UNITED STATES PATENT AND TRADEMARK OFFICE

APPLICATION NO.	FILING DATE	FIRST NAMED INVENTOR	ATTORNEY DOCKET NO.	CONFIRMATION NO.
10/693,504	10/27/2003	Tsuyoshi Matsumura	03180.0339	3147

Office Action Summary

DETAILED ACTION

Attachment = 1

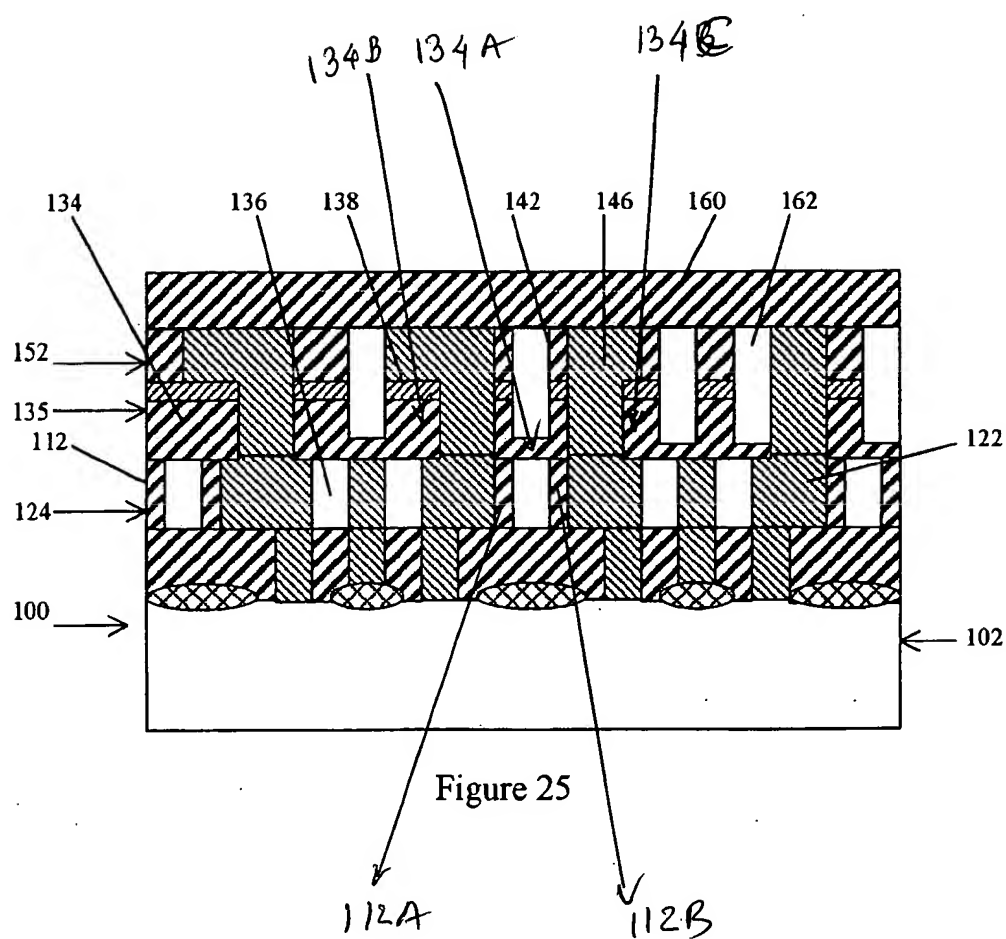
With regard to claim 1, Pang et al. discloses a underlying insulating film 110; a first sidewall insulating film 112A disposed on the underlying insulating film 110; a second sidewall insulating film 112B disposed on the underlying insulating film 110, opposite to the first sidewall insulating film 112A so as to provide a cavity between the first and second sidewall

insulating films (112A,112B) having the same height as the first sidewall insulating film 112A; and upper insulating film 134 provided over the first and second sidewall insulating films (112A,112B). (Note attachment # 1, figs. 1,18,25 of Pang et al.).

With regard to claim 2, Pang et al. discloses a central beam 134A over the first and second sidewall insulating films (112A,112B) so as to seal an upper portion of the cavity; a first side-beam 134B disposed on the first sidewall insulating film 112A having the same height as the central beam 134A; and a second side-beam 134C disposed on the second sidewall insulating film 112B and having the same height as the first side-beam 134B so as to sandwich the central beam 134A with the first side-beam 134B. (Note attachment # 1, figs. 1,18,25 of Pang et al.).

FIG. 4 PRIOR ART

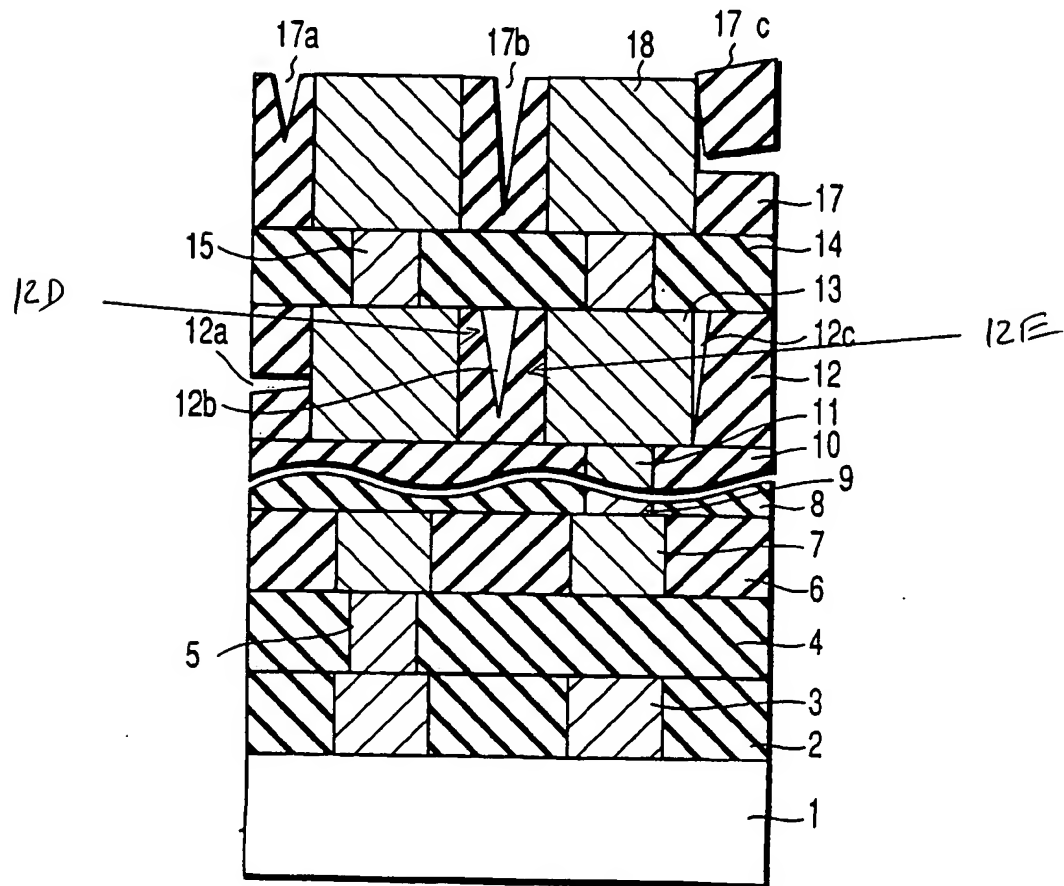
However, Shimooka et al. discloses a top portion width of the first sidewall insulating film 12D contacting the upper insulating film 14 is narrower than a middle portion width of the first sidewall insulating film 12D spaced from the upper insulating film 14 and a top portion width of the second sidewall insulating film 12E contacting the upper insulating film 14 is narrower than a middle portion width of the second sidewall insulating film 12E spaced from the upper insulating film 14. (Note attachment # 2, fig. 4 of Shimooka et al.).

Therefore, it would have been obvious to one of ordinary skill in the art to form the Pang et al.'s device having a top portion width of the first sidewall insulating film contacting the upper insulating film is narrower than a middle portion width of the first sidewall insulating film spaced from the upper insulating film and a top portion width of the second sidewall insulating film contacting the upper insulating film is narrower than a middle portion width of the second sidewall insulating film spaced from the upper insulating film such as taught by Shimooka et al. in order to reduce the stresses of device.
